Our ref: HGY/2022/4319 Contact: Gareth Prosser Date: 16/06/2025
Town and Country Act 1990 (As amended)		
Location:	Edmansons Close, Bruce Grove, London, N17 6XD	
Proposal:	Full planning application for the demolition of existing laundry building and 1970s infill building; alterations and extensions to 44 existing almshouses to create 8 x 1 bed, 12 x 2 bed and 6 x 3 bed units; alterations to existing Gatehouse to provide 1 x 2 bed unit; construction of 1 x new build 3 bed almshouse to replace 1970s infill building; construction of a new apartment building comprising 7 x studio units and 9 x 1 bed units; construction of 4 x new build 2 bed units within two new pavilions (2 units in each pavilion, 4 units in total); with landscaping; improvements to access; car parking; and ancillary development thereto.

Carbon Management Response 22/05/2023

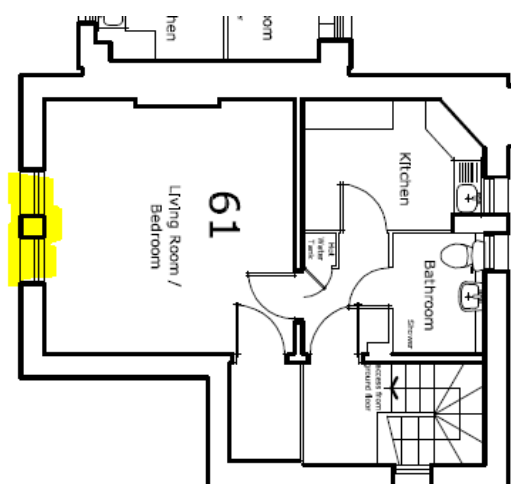
The energy note claims all bedrooms to have a secondary window not facing Bruce Grove that could be opened to provide natural ventilation. The below floor plan is an example of some single aspect bedrooms with only one window facing the Bruce Grove Road. Therefore, please assess the development taking into account the noise consideration under predominantly mechanically ventilated criteria.
